Heritage Response

DM/25/0780 and DM/25/0781 Red House Farm, Cowfold Road, Bolney

This statement provides a response to the Conservation Officer's comments in respect of the proposals for internal alterations and a two storey rear extension to the Grade II Listed Red House Farm and clarifications where required.

Phase Dii - Mid 1900s

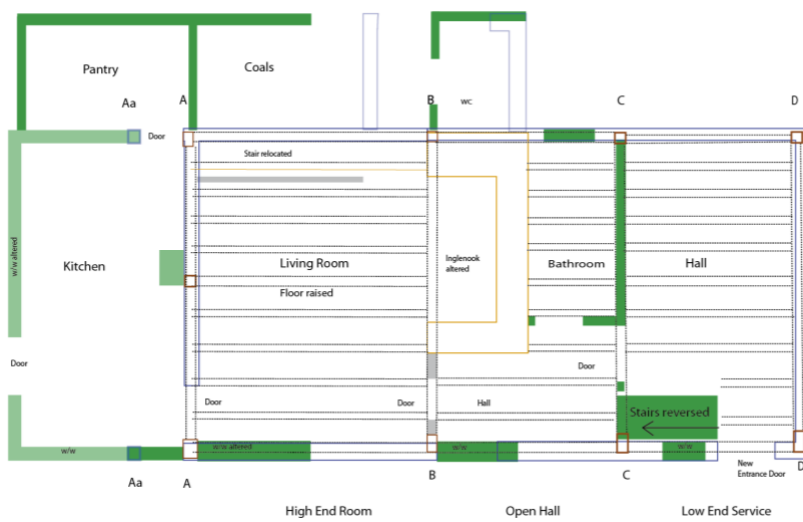
Alterations in Progress circa 1950s. The ground floor saw an additional skin added including to the north elevation. The doorway at Aa-A was removed and the roof was in the process of being altered from a gable to a barn hip.
